**Re: 8 Cole Drive and 24 Davis Drive
Section 94.02, Block 1, Lots 8 and 9**

RE: Nazar Massouh & Pudding Pie II, LLC
8 Cole Drive & 24 Davis Drive
Section 94.02 Block 1 Lots 8 & 9

Our office is in receipt of your review memorandum of the lot line realignment for the above referenced property. The applicant is proposing to realign the property between (2) existing developed lots, 8 Cole Drive (currently 5.9 acres) and 24 Davis Drive (currently 10.7 acres). In addition to the lot line change, the applicant is also proposing a realignment of the existing driveway serving 24 Davis Drive. Doing so would remove any portion of the existing driveway from the proposed reconfiguration of the adjusted common property line. Plans have been updated to address comments discussed in your letter to the Planning Board dated November 5, 2020. Plans and comments have been addressed as follows:

TITLE:
INTEGRATED PLOT PLAN

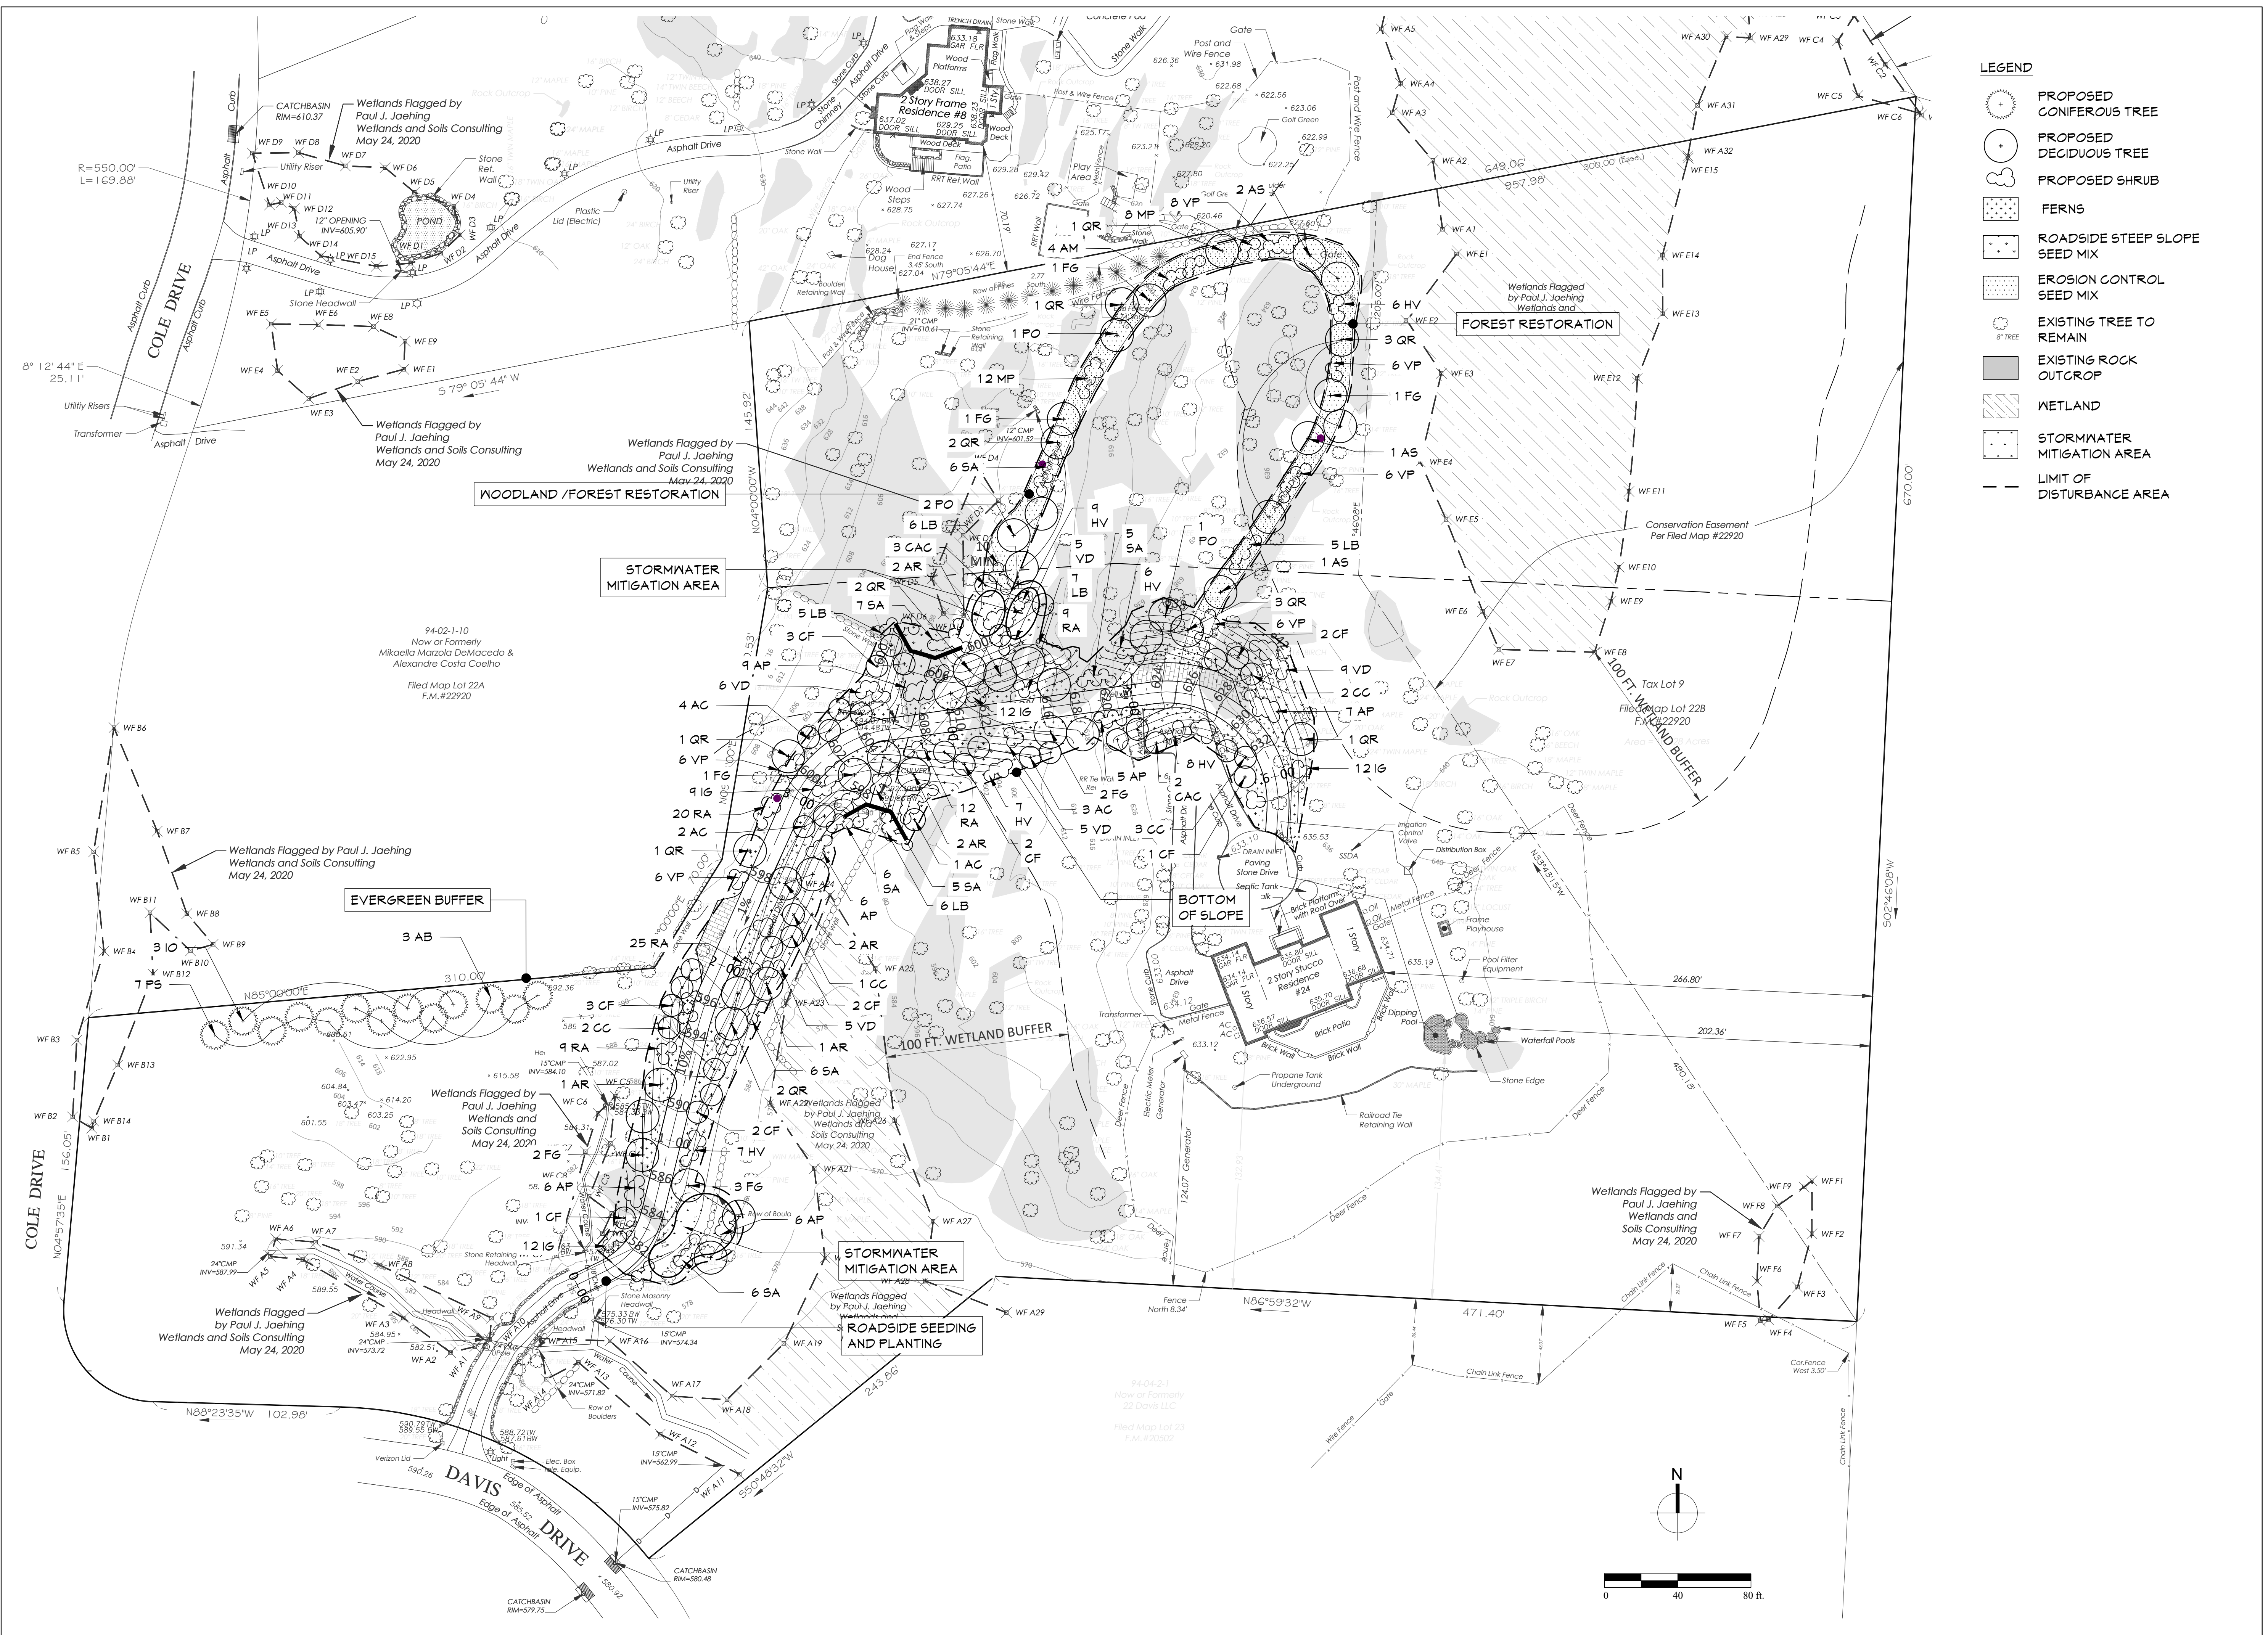
2. *While the proposed realignment results in a shorter driveway, as compared to existing conditions, it will still exceed 700 feet in length. The plan currently proposes a driveway width of 12 feet. While we agree that a 12 foot wide drive is appropriate, the applicant should provide wider pull-off areas strategically placed along the length of the drive to allow for passing vehicles. In addition, we recommend that the plan be referred to the Armonk Fire Department for review for adequate emergency access.*

Response: The wetland consultant will schedule an inspection to confirm the delineated wetland line.
 - b. *The Preliminary Plat shall be revised to illustrate existing topography and illustrate and quantify areas of Town-regulated steep slopes (similar to that shown on the IPP) to support the area deductions proposed.*

Response: The plans have been updated to provide pull off areas, strategically placed, to allow for approaching vehicles to be seen and to pass. Two pull off areas are provided. Each location will provide for sight lines to allow vehicles to pull over in the event another is approaching. Plans will be referred to the Armonk Fire Department for review of adequate emergency access.

Response: The Preliminary Plat has been updated to illustrate the existing topography. The total areas supporting deductions have been included on the zoning chart.
